**Classification:**  
 AT09-009b

**Reference:**  
 ITB09-032b

## 7 SPEED A/T HARSH 4>3 DOWNSHIFT ON DECELERATION

Figure 1

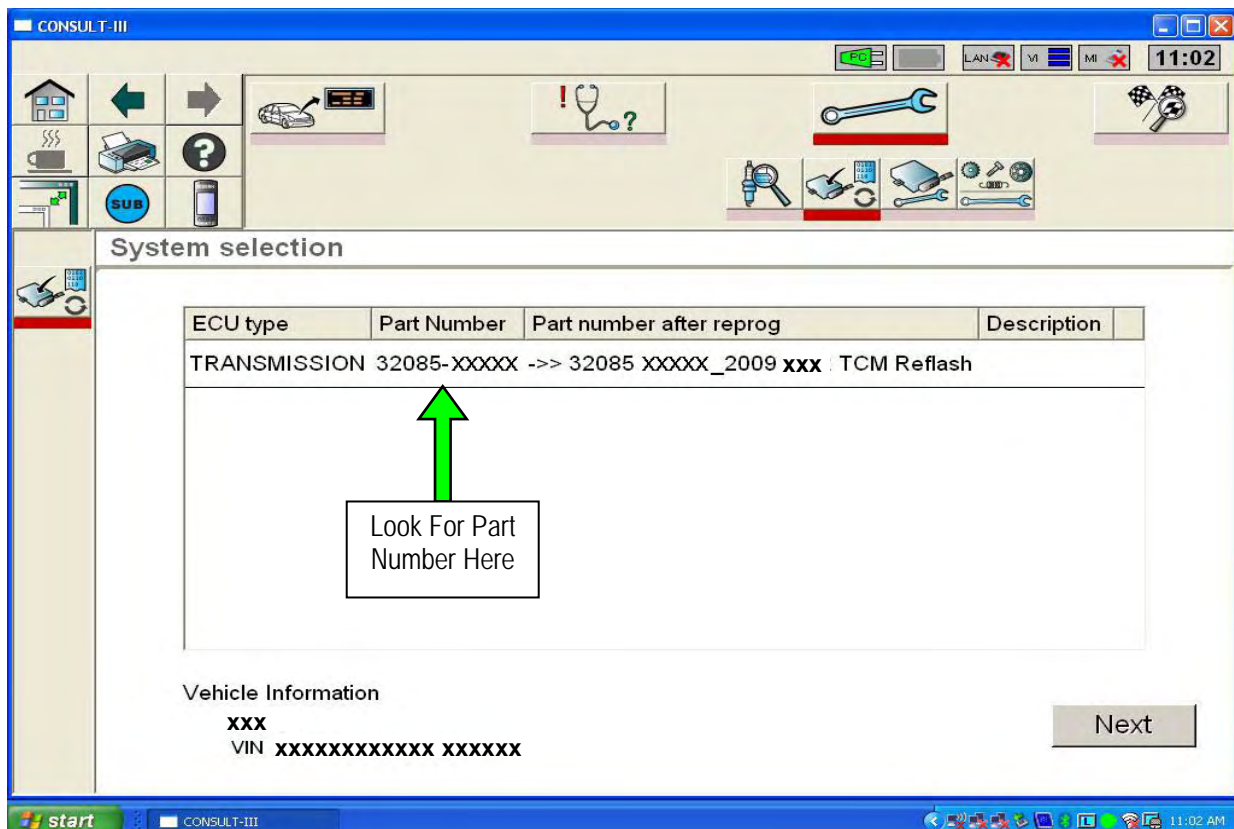
2. When you get to the TCM Reprogramming screen shown in Figure 1, confirm this bulletin applies as follows:
  - A. On your C-III screen, look at the **Part Number** column (see Figure 1 example).
    - If this column is **blank** (no part number listed), this **bulletin does not apply**.
    - If a Part Number (P/N) is listed, write it on the Repair Order and then go to Step B.

B. Compare the P/N you wrote down to the numbers in the **Current TCM P/N** column in **Table A** below.

- If there is a match this bulletin applies. Continue with the reprogramming procedure.

- If there is not a match this bulletin does not apply.
